Service Bulletin

NX 23.00 with XRDI 23.1, ASC 10.1 and SC 5.9 released

Title:	DX-D 100 Wireless - SB177 - NX 23.00 with XRD1 23.1, ASC 10.1 and SC 5.9 released
Livelink ID:	76568538
Version#:	4
Version Date:	2021-05-07 10:35 AM CET
Status:	Approved on 2021-05-18 01:26 PM CET
Owner:	Anja Lekies (expie)
Created By:	Anja Lekies (expie)
Created Date:	2021-04-19 02:23 PM CET
PDF Creation Date:	2021-05-18 01:26 PM CET

Figure 1

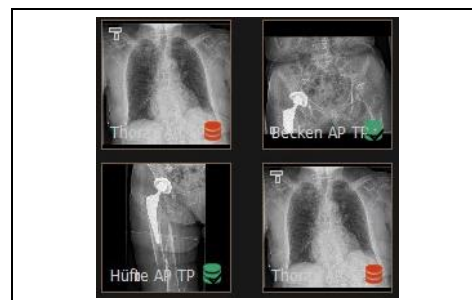
1.1 Solved problem records in NX 23.00**1.1.1 Sporadically archiving of images fails with error MESS553 [PRB2000546]**

Symptom Sporadically the following error message appears when the user tries to archive an exam:

One or more archive jobs in queue <queue name> have been refused by the destination device [Ref. MESS 553]. Contact your system administrator

The image thumbnail of the affected exposure shows a red archive symbol.

The error only appears if **all** three of the following conditions are met:

- Windows 10 PC
- NX 22.00 SU1
- User creates a complex collimation polygon

Cause Software issue: Mismatch in code that checks the correctness of a collimation polygon on an image in 32-bit mode versus 64-bit mode.

Workaround Create a less complex collimation polygon or use a simple rectangle collimation and retry archiving.

Solution The issue is solved in NX 23.00.

Figure 2

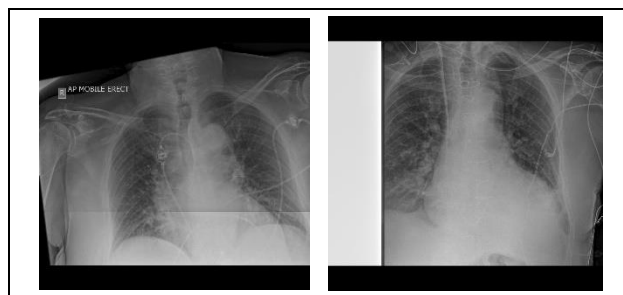
1.2.2 Images with artifacts due to big log-files [PRB2000594]

Symptom Images with artifacts or partial images appear sporadically. Note that a large logfile can also cause performance issues as it consumes too much memory. This can happen on all systems with Sedecal SoftConsole.

Cause The **Sedecal.GUI.Controls.WPF.log** log file has become too large and therefore the system did not work correctly anymore. The detector starts integrating, but the exposure comes later.

Solution Update to NX 23.00, XREDI 23.1, Sedecal SoftConsole 5.9 and related DR installers.

In SC 5.9 the issue is solved:

- The log file is prevented from becoming too big.
- The sending thread now waits for a message to be sent.
